# PENRITH CITY COUNCIL

## MAJOR ASSESSMENT REPORT

<b>Application number:</b>	DA18/0298
<b>Proposed development:</b>	Construction of a Nine (9) Storey Mixed Use Development including Two (2) Ground Floor Commercial Tenancies, 48 Residential Apartments & Ground Floor, Level 1 & Level 2 Car Parking
<b>Property address:</b>	15 Engineers Place, PENRITH NSW 2750
<b>Property description:</b>	Lot 3008 DP 1184498
<b>Date received:</b>	26 March 2018
<b>Assessing officer</b>	Kathryn Saunders
<b>Zoning:</b>	Zone B2 Local Centre - LEP 2010
<b>Class of building:</b>	Class 2
<b>Recommendations:</b>	Approve

**Figure 1:** Excerpt from AS 2890.1 (Figure 3.3) - Sight Lines

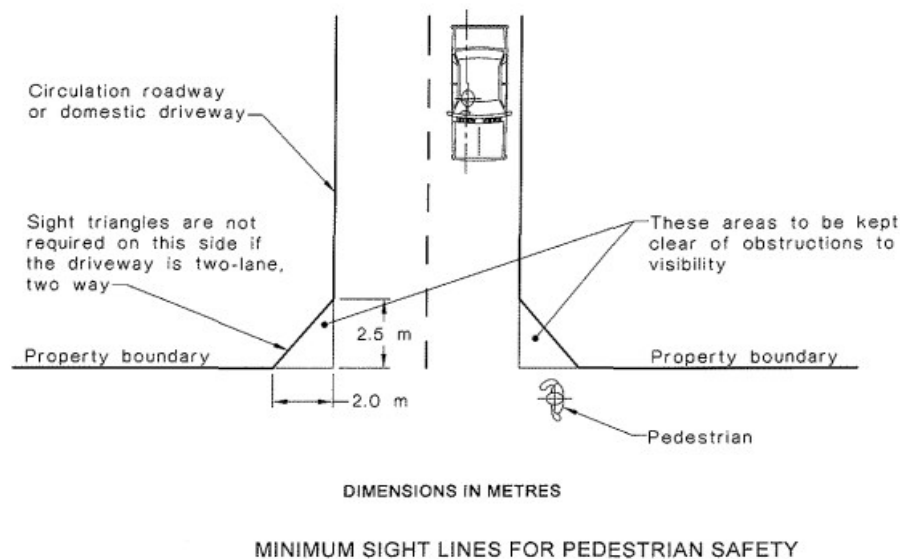
As detailed elsewhere within this report, Figure 3.3 of AS 2890.1 indicates that a splayed corner of 2m x 2.5m is to be provided at the corner within the site boundaries (see Figure 1 below).

**Figure 2 -** Proposed splay and curved building envelope in plan

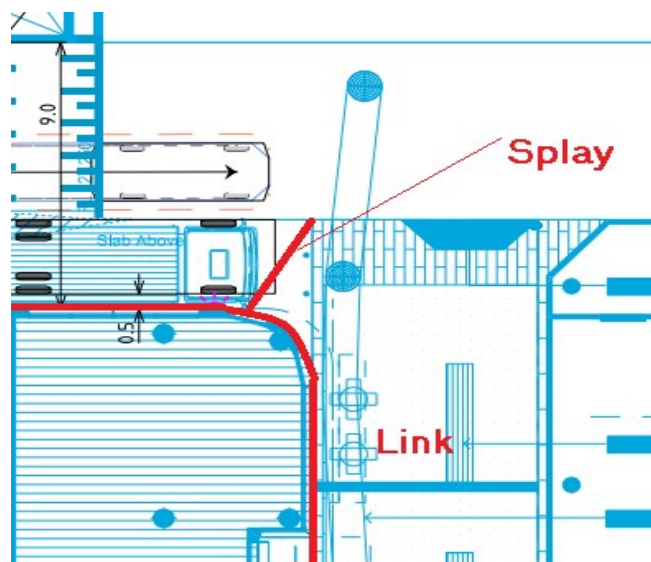
The proposal is for a 2.1m x 2m curved splay at the corner (refer Figure 2 below). It is noted that there is no pedestrian way provided along the service lane and that a 3m wide waste collection bay is provided in addition to the 6m wide carriageway. The service lane does not contain pedestrian access points to residential units meaning that the pedestrian desire line is not to the north. Notwithstanding this, given that pedestrian movements cannot be guaranteed, conditions of consent are recommended to include:

- the installation of two bollards at the north-eastern corner of the through-site link,
- a warning light indicating waste collection movements are being undertaken, and
- the provision of a splayed egress kerb to direct vehicles using the waste collection area to be positioned away from the corner and provide a buffer area for a pedestrian if the a vehicle is exiting the waste bay. In addition, it is noted that there is a kerb provided at the road/pedestrian through-site link interface which will add to visual awareness for pedestrians in this location.
